## Safety Recall Launch Notification

Campaign #	NHTSA ID	Campaign Codeword	<b>Retrofit Cover on Airbag Control Unit</b>
2026030003	26V070	VS2KORSRS

<b>Total Recall Population</b>	52,358	<b>Model(s)/ Platform(s)</b>	Metris RHD (447)
<b>Vehicles in Dealer Inventory</b>	0		
<b>Model Year(s)</b>	2020, 2022-2023		
<b>Issue</b>	MBAG, the manufacturer of Mercedes-Benz vehicles, has determined that on certain right-hand-drive Metris (447 platform) vehicles, increased amounts of condensation might accumulate on the outside of the air distribution housing of the air conditioning under certain operating conditions, and seep onto the airbag control unit positioned beneath it. Over time, condensation on the airbag control unit might lead to corrosion in the electrical connector of the control unit and impede the deployment of the airbag, which could increase the risk of injury in the event of a crash.		
<b>What We're Doing</b>	MBUSA will conduct a voluntary recall. An authorized Mercedes-Benz Metris dealer will install a protective cover over the airbag control unit on the affected vehicles.

S68.10-A089-75

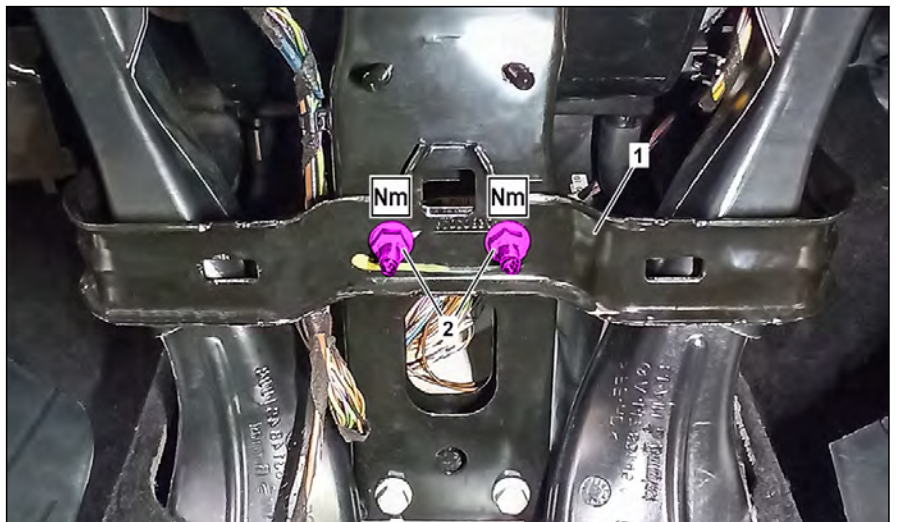
6.1 	Remove trim at bottom for center instrument panel.	Model 447 except code FJ3 (double cup holder, cockpit center)	AR68.10-S-1498E
6.2 	Remove cup holder.	Model 447 with code FJ3 (double cup holder, cockpit center)	AR68.00-S-1000E
7	Remove holder (1).	To do this, unscrew nuts (2).	
	<b>Retrofit</b>		
8	Retrofit protective cover (3) over the supplemental restraint system (SRS) control unit (N2/18).	Install protective cover (3) without knocking other component parts. Otherwise, noises may occur while driving. Position protective cover (3) centrally between supplemental restraint system (SRS) control unit (N2/18) and air conditioner box. Attach protective cover (3) to crossmember using two cable ties (4).	
9	Glue mat (5) to front area of air conditioner box.	The bonding area must be completely dust and grease-free. Otherwise, adhesion problems may occur. Cut mat (5) to correct length and glue in diagonally (from top left to bottom right, as shown).

<b>Install</b>		
10	Install holder (1).	Tighten nuts (2) to specified tightening torque. M8×1	BA00.10-Z-1001-02KOA
11.1 	Install cup holder.	Model 447 with code FJ3 (double cup holder, cockpit center)	AR68.00-S-1000E
